UNITED STATES PATENT AND TRADEMARK OFFICE

APPLICATION NO.	FILING DATE	FIRST NAMED INVENTOR	ATTORNEY DOCKET NO.	CONFIRMATION NO.
10/075,216	02/14/2002	Michael Alois Kolowski	DN2002024	7021

Office Action Summary

- 1) ☒ Responsive to communication(s) filed on 28 April 2005.
- 2a) ☒ This action is FINAL. 2b) ☐ This action is non-final.
- 3) ☐ Since this application is in condition for allowance except for formal matters, prosecution as to the merits is closed in accordance with the practice under *Ex parte Quayle*, 1935 C.D. 11, 453 O.G. 213.

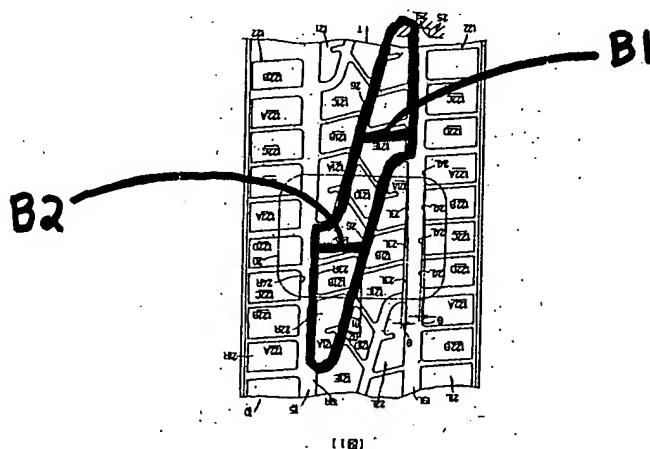
The claimed tread reads on the tread having the tread pattern shown in figure 1. The claimed central array reads on the "central array" comprising seven blocks 121A, 121B, 121C, 121D, 121E, etc. Japan '207 teaches delimiting the central array using slant grooves 26 and portions of grooves 19L, 19R. The slant grooves have oppositely curved end sections. The slant grooves 26 are inclined at an angle of 1-15 degrees with respect to the circumferential direction and the portions of grooves 19L, 19R are slightly inclined at an angle of for example 2 degrees. Figure 1 of Japan '207 is reproduced below with markings added by the examiner:

The markings added by the examiner indicate one of the central arrays of tread elements and shows example boundaries B1 and B2 of a "midsection" of the array. As to claim 17, the arrays overlap. For example block 121A (a block at the end of one

array) is adjacent a block 121D (a middle block of another array). As to claim 29, Japan '207's teaching to taper the blocks adjacent grooves 19L, 19R at 2 degrees forms a shoulder groove as claimed.

As to each array widening continuously from the first and second ends to the array midsection / the relatively wider midsection, claims 17 and 29 continue to read on Japan 207's array and fail to require an extent of widening at each end of the array longer than that shown by Japan 207 in figure 1. The term "midsection" (which is not defined in claims 17, 29 or the original disclosure) is sufficiently broad to read on a section of Japan 207's array comprising block 121D and at least a portion of blocks 121C and 121E. As can be seen from Japan 207's figure 1, Japan 207's array continuously widens from the end of block 121A to the middle of block 121C. The subject matter of "widening continuously" is describing *the array width between* the end and the midsection instead *of the array width of* the midsection. Claims 17 and 29 fail to require either a portion of or the entirety of the midsection to be wider than the section of the array between the midsection and either end of the array. The above noted marked up copy of Japan 207 indicates an example of the boundaries of a midsection. See lines B1 and B2. The width of the midsection at lines B1 and B2 is "relatively wide" because it is wider than the width of the slant groove 26 or block 121A. The array continuously widens from one end of the array to boundary B1 and from the other end of the array to boundary B2.
